**Re: Request for Permit Modification to change an Approved C-147 Containment and Recycle Facility (2RF-114) from a Non-commercial to a Commercial Recycle Facility and add an AST in Eddy County, New Mexico**

Devon Energy (OGRID #6137) would like to request permission to modify the permit issued for their Todd 2 Containment and Recycle Facility (2RF-114). This is a request for a permit to change the non-commercial Todd 2 facility to a commercial facility and add an Above-Ground Storage Tank (AST).

AST LEAK DETECTION PLAN

TODD 2 RECYCLE  
DEVON ENERGY  
SECTION 2, TOWNSHIP 23 SOUTH, RANGE 31 EAST LEA COUNTY, NM

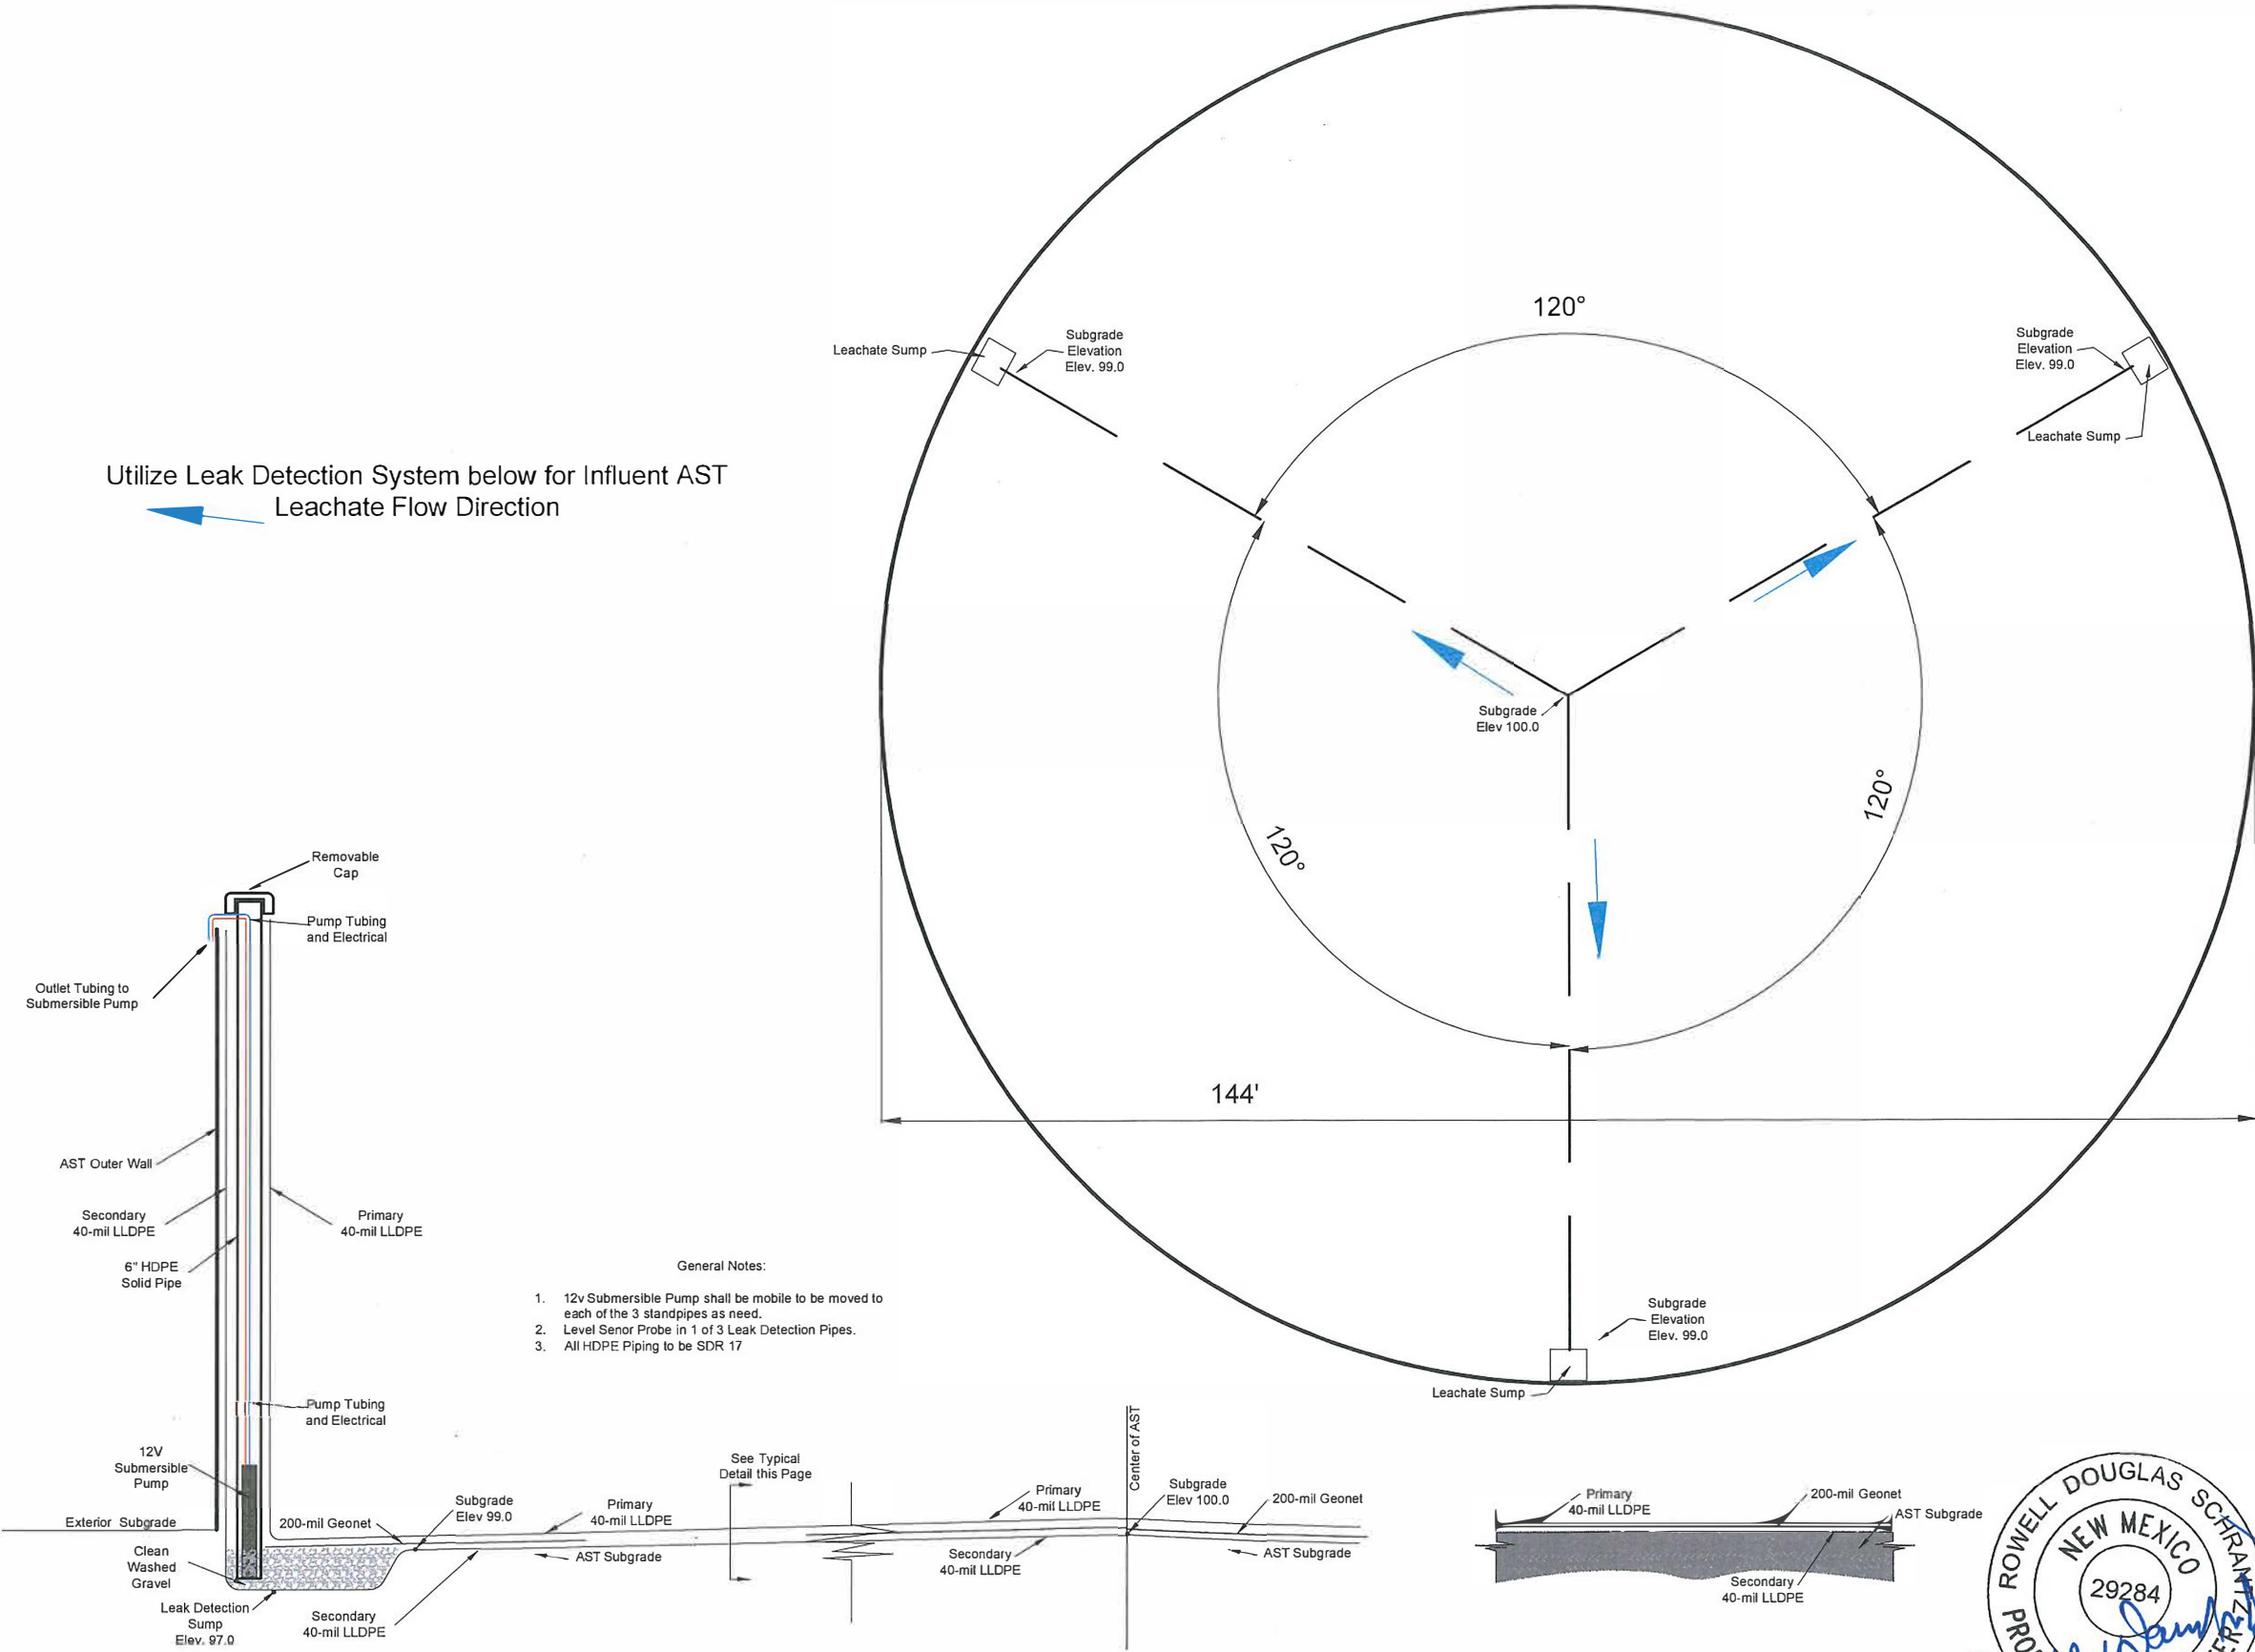
Devon Energy (Devon) is requesting a variance to Rule 34 Part 12(A)(3) requiring *"The edges of all liners shall be anchored in the bottom of a compacted earth-filled trench."*

Devon is requesting approval to use an Above Ground Storage Tank (AST) as a containment structure at the Todd 2 Recycle Facility. Based on our experience AST's work well for this purpose, they are structurally sound and easy to maintain. Clips will be used at the top of the steel walls to secure the liner. These clips are specifically designed to hold the AST liner in place and provide the same type of liner security as an anchor trench. It should also be noted that this variance has been granted on past sites.

- The variance to 19.15.34.12.A.(2) NMAC for the no side-slope requirement for the AST containment with vertical walls is approved.
    - The variance to 19.15.34.12.A.(3) NMAC for the liners to be anchored to the top of the AST steel walls and no anchor trenches is approved.
